DRAINAGE AND TRANSPORTATION INFORMATION SHEET (REV 6/2018)

Project Title: 6432 PETIRROJO **Building Permit #:** _____ **Hydrology File #:** _____
DRB#: _____ **EPC#:** _____ **Work Order#:** _____
Legal Description: LOT 4, Block 9 VOLCANO CLIFFS UNIT 22
City Address: 6432 PETIRROJO

RE: **Lot 4 Block 9 Volcano Cliffs Unit 22 SAD 228**
6432 Picardia Pl. NW
Grading and Drainage Plan
Engineers Stamp Date 2/21/2021 (D10D003Q4)
Pad Certification Date 5/2/2021

ENGINEER'S SEAL	LOT 4 BLK 9 U 22 VC 6432 PICARDIA PL N.W.	DRAWN BY DEM
		DATE 2-20-21
		LOT 4 BLK 9 U 22 VC DWG
		SHEET # C1
2/21/21	 PO BOX 83624 ALBUQUERQUE, NM 87199 (505) 321-9099	JOB # _____
DAVID SOULE P.E. #14522

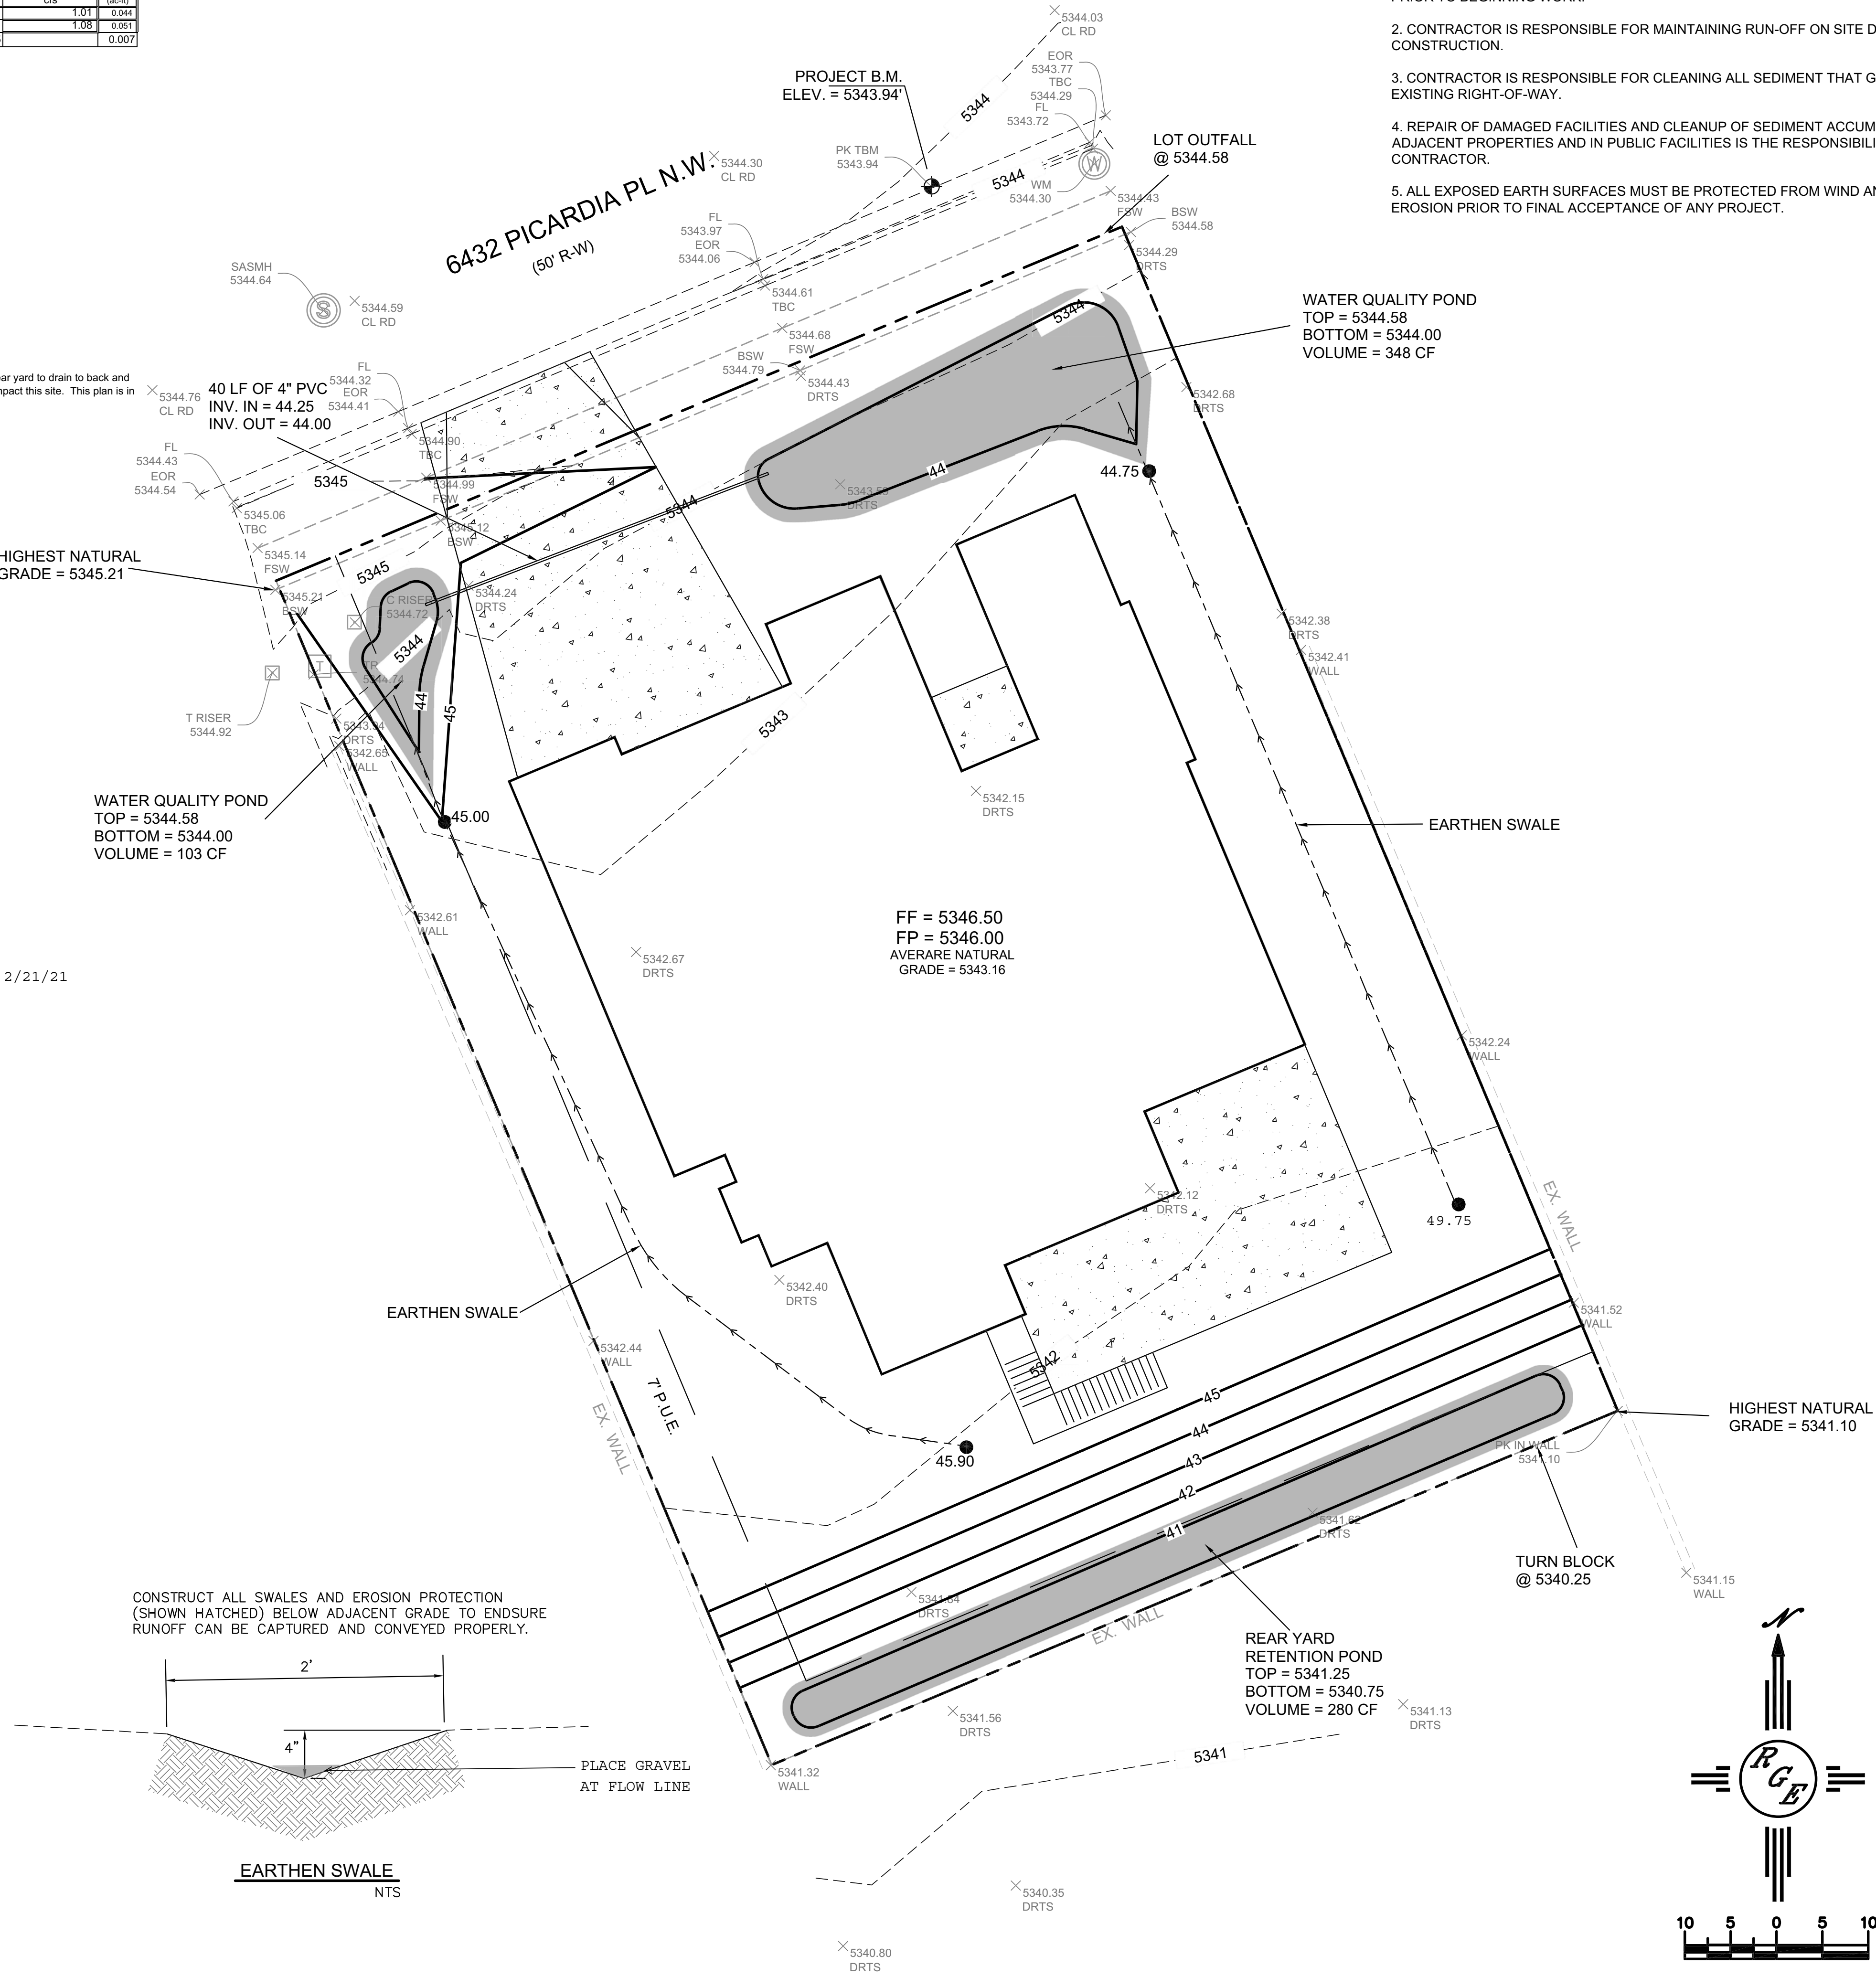
PO Box 1293
Based upon the information provided in your submittal received 5/7/2021, this plan is approved for Building Permit.

Albuquerque
Please inform the builder/owner to attach a copy of this approved plan and this letter to the construction sets in the permitting process prior to sign-off by Hydrology.

NM 87103
Reiterate to the Owner/Contractor that a separate permit for a garden/retaining wall must be obtained, with the approved G&D plan and Pad Certification. Also, let the owner/contractor know that if a pool is to be added in the future the G&D plan will need to be modified showing the location of the pool and the land treatment differences.

www.cabq.gov
Prior to Certificate of Occupancy release, Engineer Certification per the DPM checklist of this plan will be required.
